**WARRANTY
BULLETIN**

Wb02-11

DATE : May 2002	SECTION : 06 - Electrical
EXPIRATION: May 2003	
SUBJECT : PROTECTION OF CIRCUITS 103 AND 7B INSIDE FRONT SERVICE COMPARTMENT

FIGURE 1: LOCATION OF WIRES INSIDE FRONT SERVICE COMPARTMENT

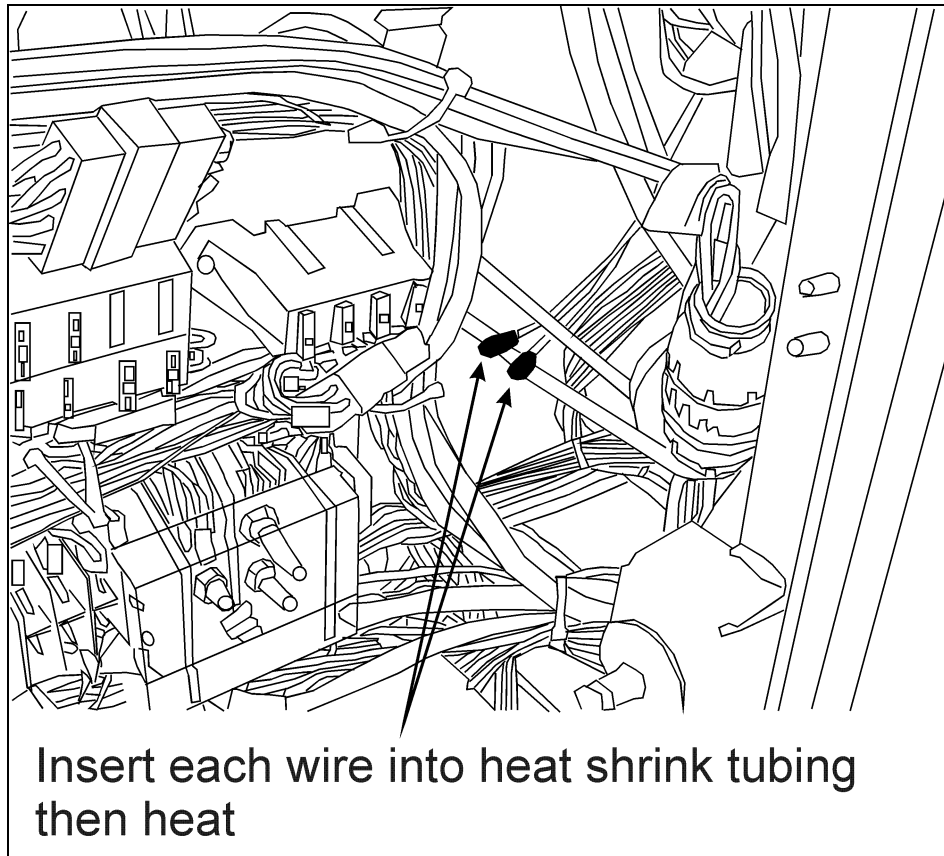
For the above-mentioned vehicles equipped with front suspension kneeling system but without high buoy or low buoy suspension system, a heat shrink tubing must be added to circuit 103 and 7B wire end.

1. Open front service compartment door.
2. Locate wires 103 and 7B (refer to figure 1).
3. Cut one piece of heat shrink tubing to isolate each wire end.
4. Insert each wire into heat shrink tubing then heat.
5. Secure wires inside compartment.
